Office Action Summary	Application No. 10/575,499	Applicant(s) JAMES, PETER	
	Examiner RYAN D. KWIECINSKI	Art Unit 3635

DETAILED ACTION

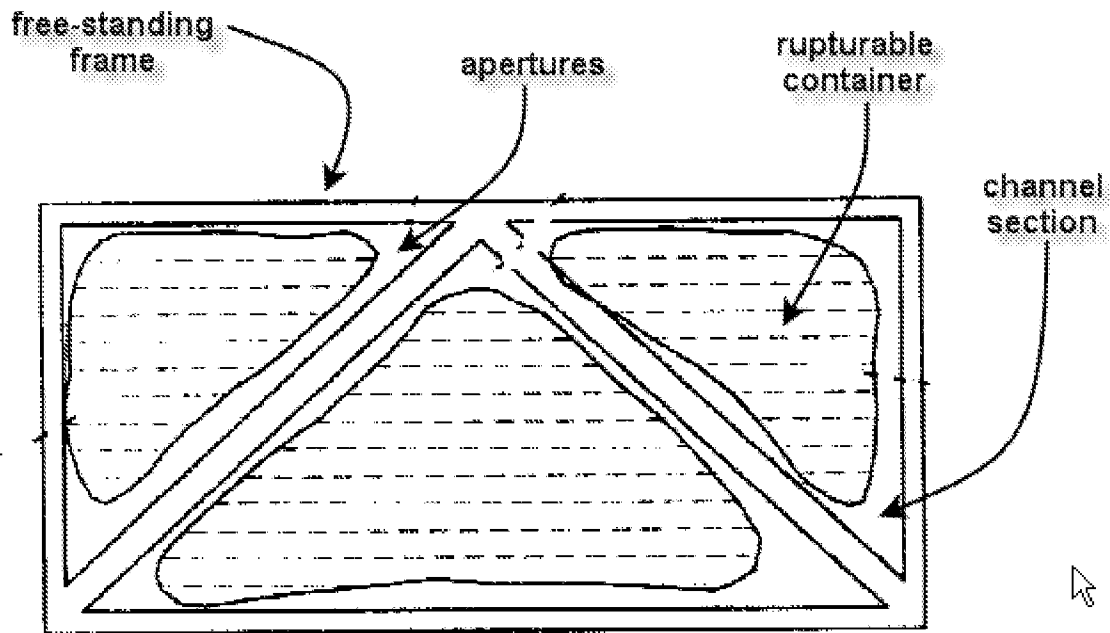
Claims 1, 3-6, 8, and 12-13 are rejected under 35 U.S.C. 102(b) as being anticipated by US 6,302,026 B1 to Parkes.

Parkes discloses a blast mitigation structure comprising one or more rigid free-standing frames (see figure above) of one or more channel section (see figure above), the or each frame being adapted to receive in the or each channel, in use, one or more

rupturable containers (32, See figure above) adapted to contain liquid (Column 4, lines 3-4) to thereby form a protective tunnel (Fig.5).

Regarding claim 5 as best understood, wherein the or each rigid free-standing frame has apertures (see figure above) therein such that the exposed parts of the or each rupturable container are in the direct path of an explosion.

Regarding claim 12 as best understood, further comprising one or more rupturable containers containing liquid (32, see Figure above), the blast mitigation

Regarding claim 13 as best understood, a kit of parts capable of providing a blast mitigation structure according to claim 12 (see rejection above), the kit of parts comprising one or more rupturable containers (See figure above) adapted to contain liquid and one of more rigid free-standing frames (See figure above) of one or more channel section (See figure above), the or each frame being adapted to receive in the or each channel, in use, said one or more rupturable containers (See figure above).
